May 1, 2024

ADDENDUM NUMBER ONE (1)

Project: Madison Fire Station 3  
Addition and Renovations  
PN: 23007

FROM: Dean Architecture, P.A.  
661 Sunnybrook Road, Suite 140  
Ridgeland, MS 39157  
(601) 939-7717

**M201**

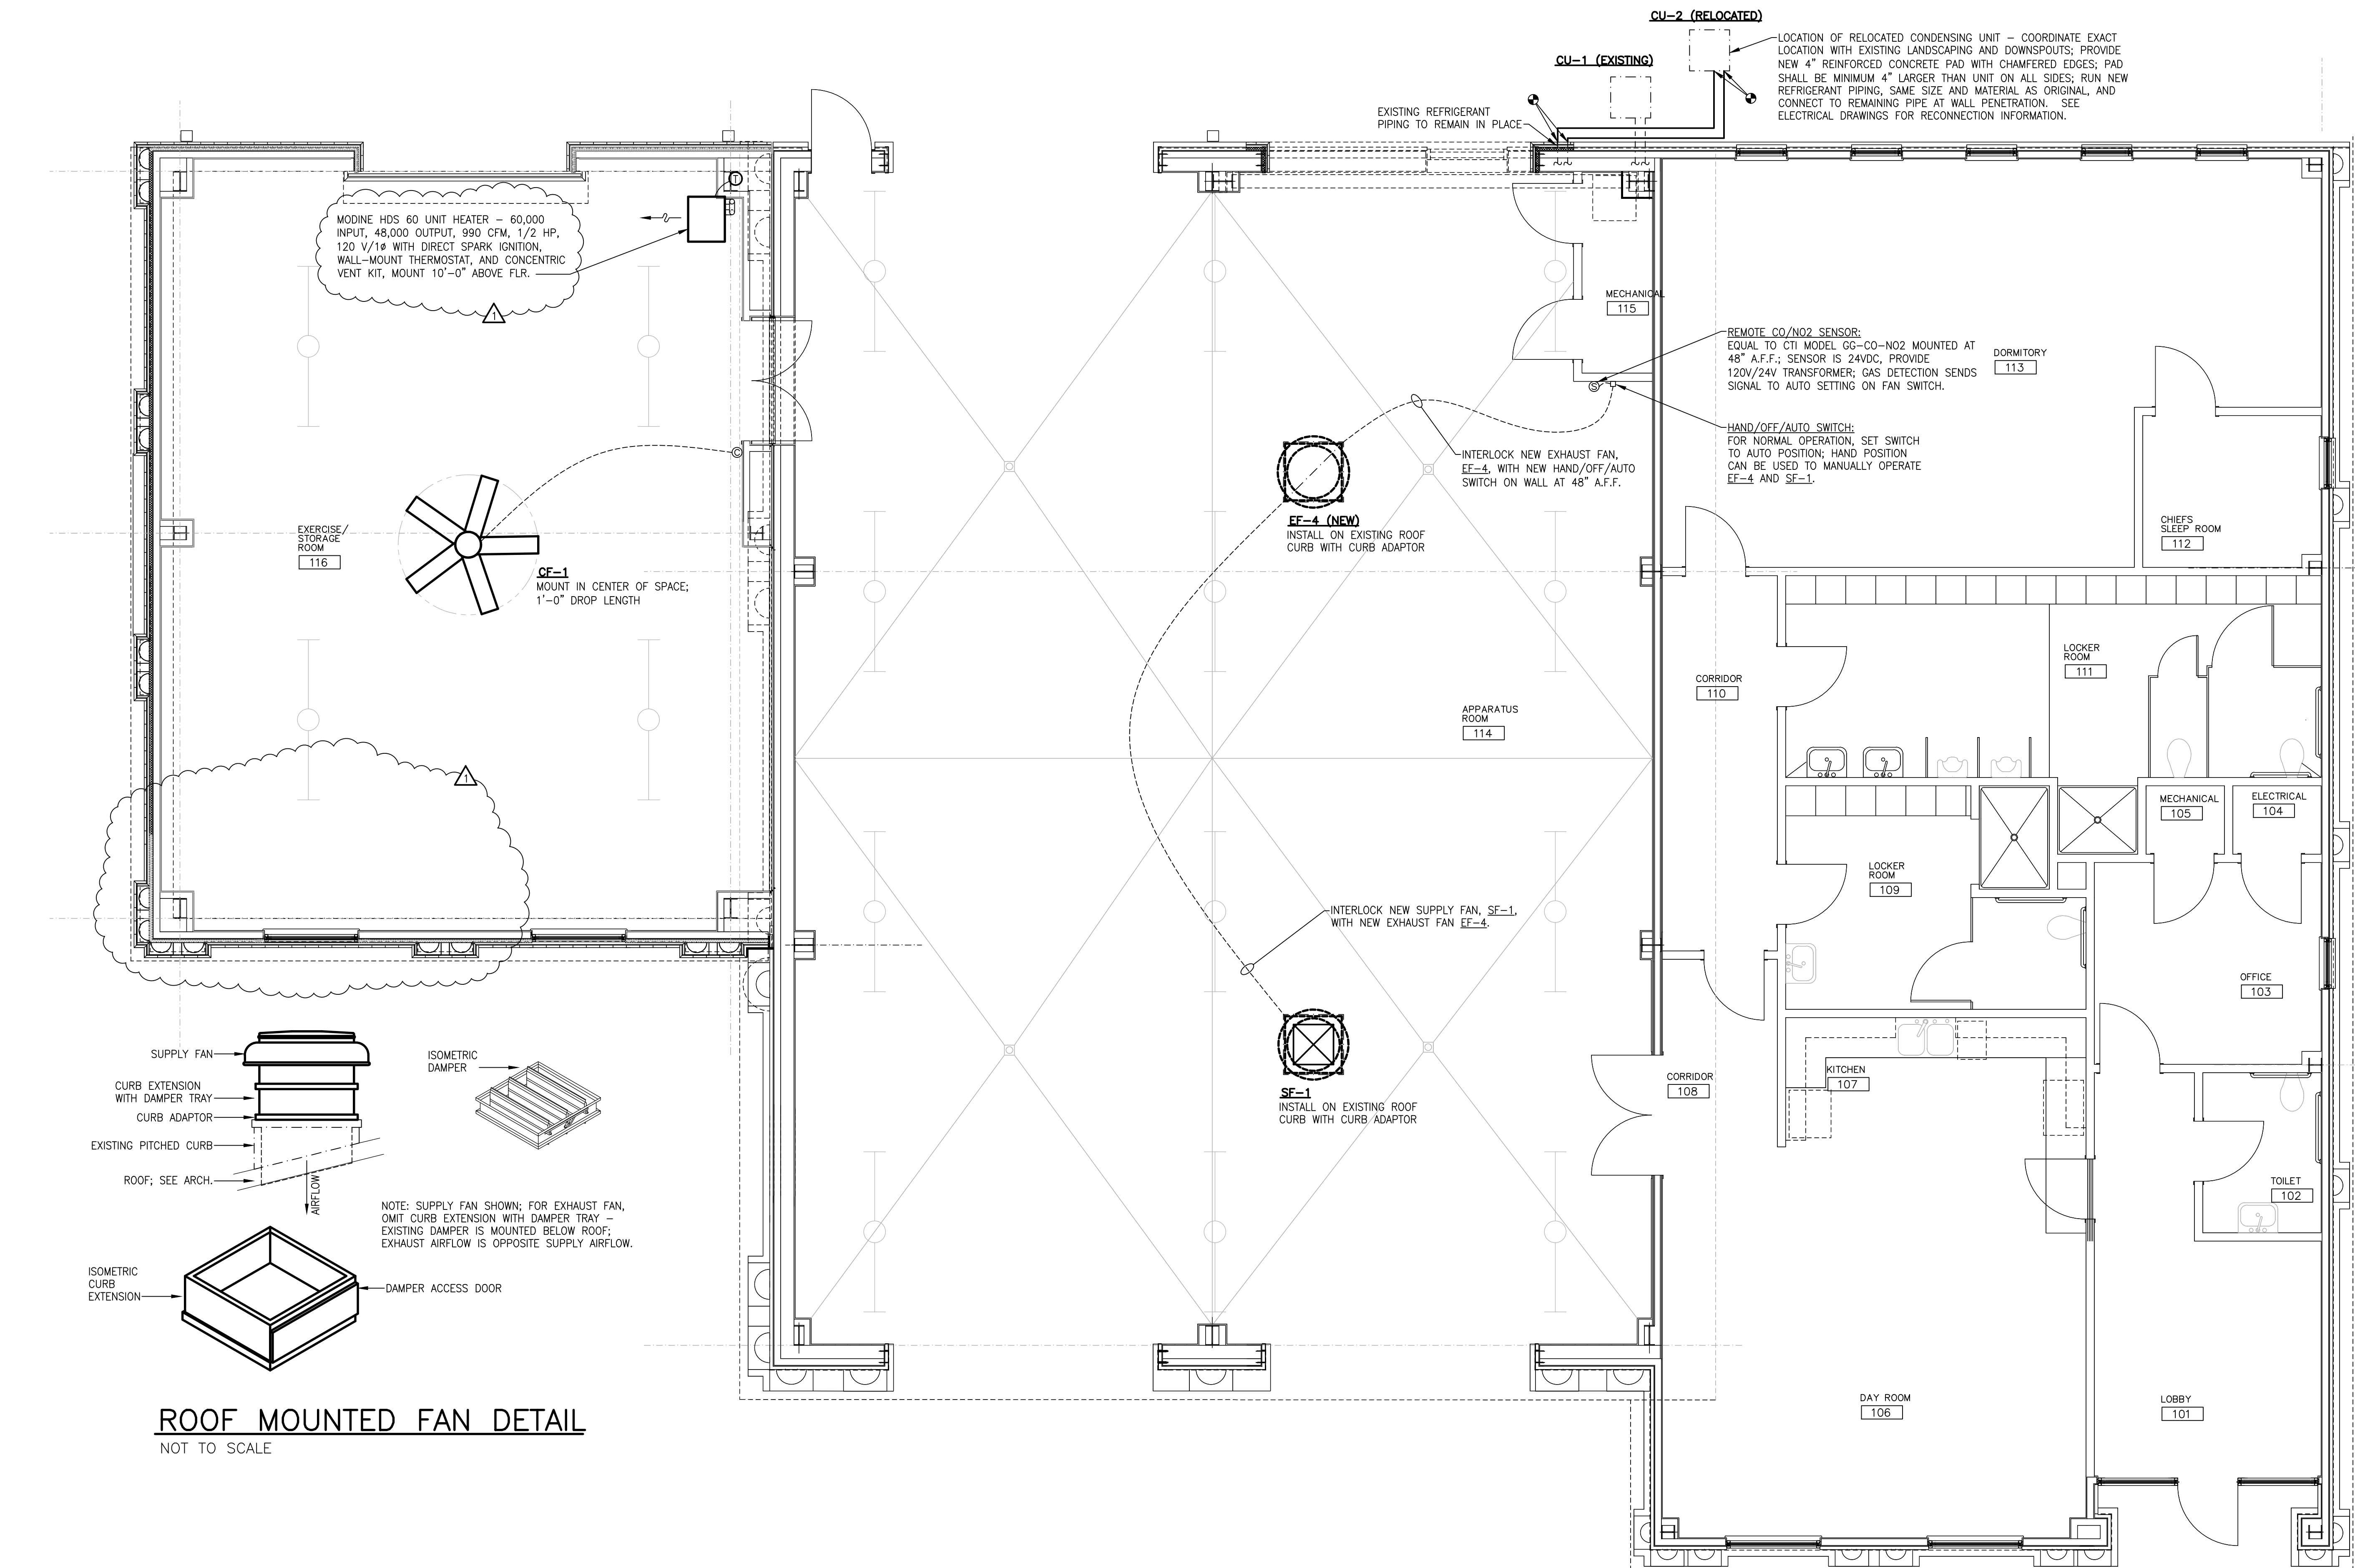
1. Replace Sheet M201 with revised Sheet M201 dated April 25, 2024. This revision deletes the gas-fired unit heater at the northeast corner of new Exercise/Storage Room 116, and increases the size of the gas-fired unit heater at the southwest corner of that room.
2. Replace Sheet P201 with revised Sheet P201 dated April 25, 2024. This revision deletes the gas piping associated with the deletion of the gas-fired unit heater mentioned in item 1.

Project No. : 23007  
Date: APRIL 25, 2024  
Drawn: KJH  
Checked: WPI  
Revisions: DELETED UNIT HEATER
